Well Name: ARCO 8 FEDERAL	Well Location: T18S / R31E / SEC 8 / NWSW / 32.7601449 / -103.8981778	County or Parish/State: EDDY / NM
Well Number: 5	Type of Well: OIL WELL	Allottee or Tribe Name:
Lease Number: NMLC029393A	Unit or CA Name:	Unit or CA Number:
US Well Number: 3001527213	Well Status: Producing Oil Well	Operator: MATADOR PRODUCTION COMPANY

Notice of Intent

Sundry ID: 2745161

**Permanent Abandonment of Federal Wells
Conditions of Approval (LPC Habitat)**

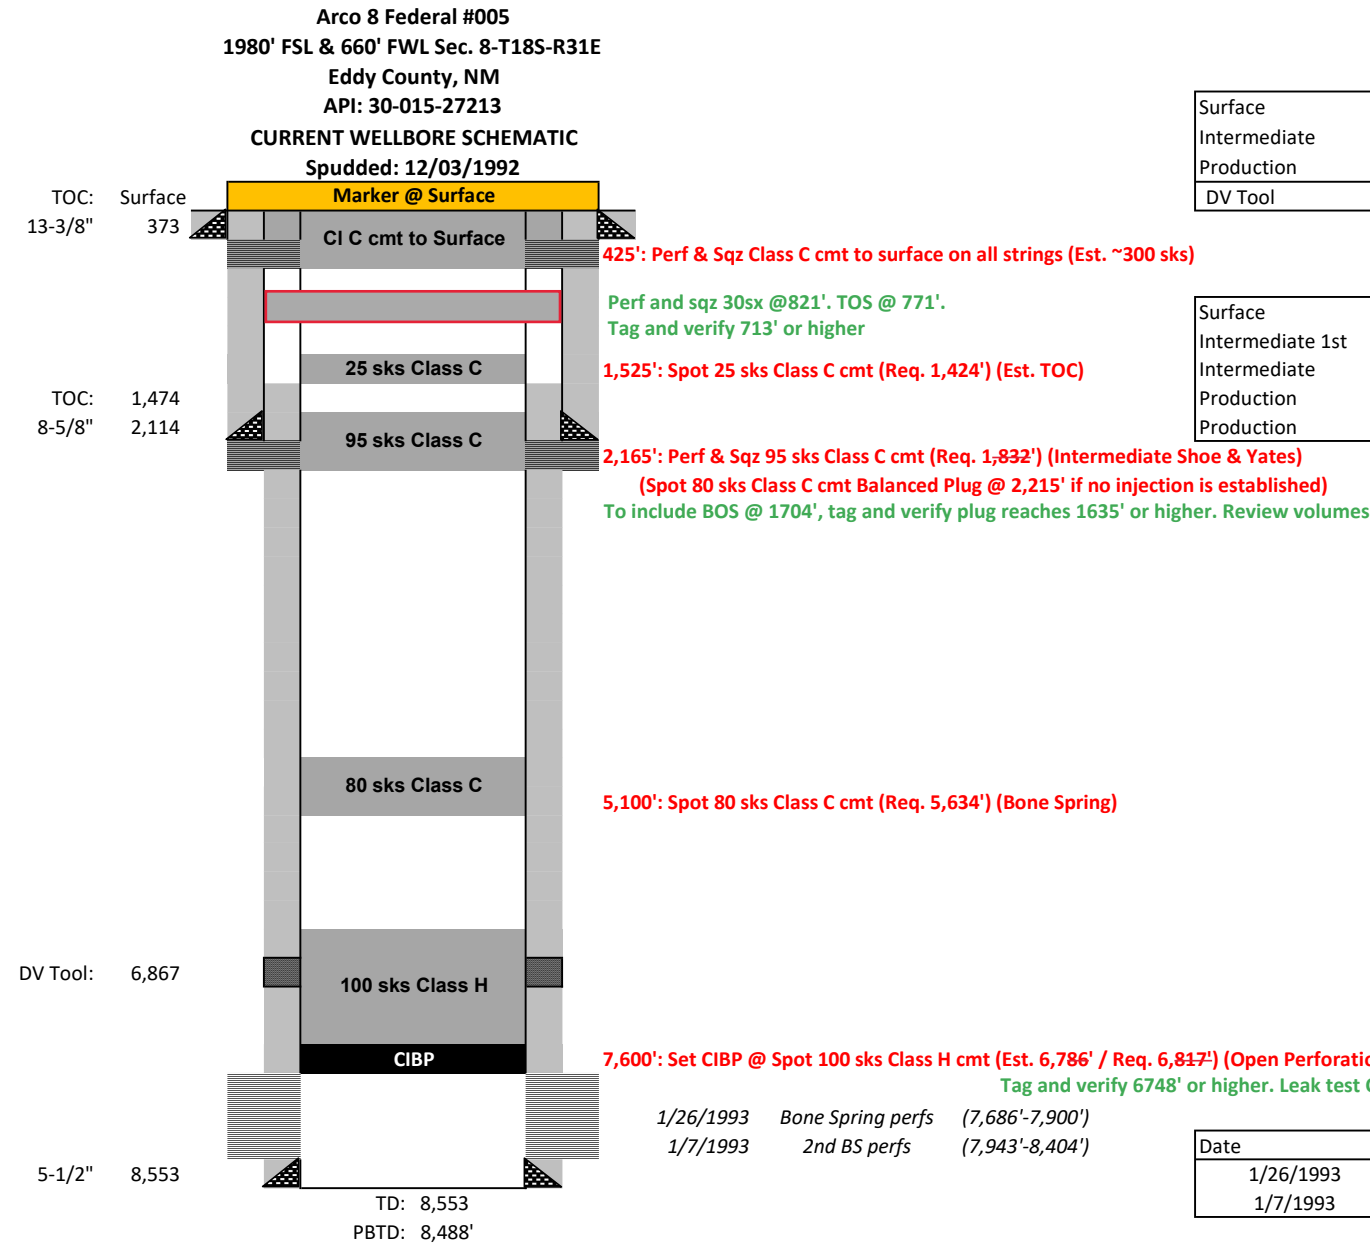
Sundry ID		2718139				
Plug Type	Top	Bottom	Length	Tag	Sacks	Notes
Surface Plug	0.00	425.00	425.00	Verify circulated to surface	300.00	Operator bringing shoe to surface. Perf and sqz
Shoe Plug	319.27	423.00	103.73	WOC and Tag	300.00	Operator bringing shoe to surface. Perf and sqz
Top of Salt @ 771	713.29	821.00	107.71	WOC and Tag	30.00	Perf and sqz
TOC 1474'. PERF AND SQZ ABOVE PLUGS						
Base of Salt @ 1704	1636.96	1754.00	117.04	WOC and Tag	80.00	Yates + Shoe + BOS. Spot OK
Yates @ 1882	1813.18	1932.00	118.82	WOC and Tag	80.00	Yates + Shoe + BOS. Spot OK
Shoe Plug	2042.86	2164.00	121.14	WOC and Tag	80.00	Yates + Shoe + BOS. Spot OK
Bonesprings @ 5050	4949.50	5100.00	150.50		80.00	
DV tool plug	6748.33	6917.00	168.67	WOC and Tag	100.00	Covered by below plug
CIBP Plug	7565.00	7600.00	35.00	Verify CIBP depth	100.00	Leak test 500psi, 30mins

No more than 2000' is to be allowed between plugs in open hole, and no more than 3000' between plugs in cased hole.

R111P: Solid plug in all annuli - 50' from bottom of salt to surface.

Onshore Order 2.III.G Drilling Abandonment Requirements: "All formations bearing usable-quality water, oil, gas, or geothermal resources, and/or a prospectively valuable deposit of minerals shall be protected."
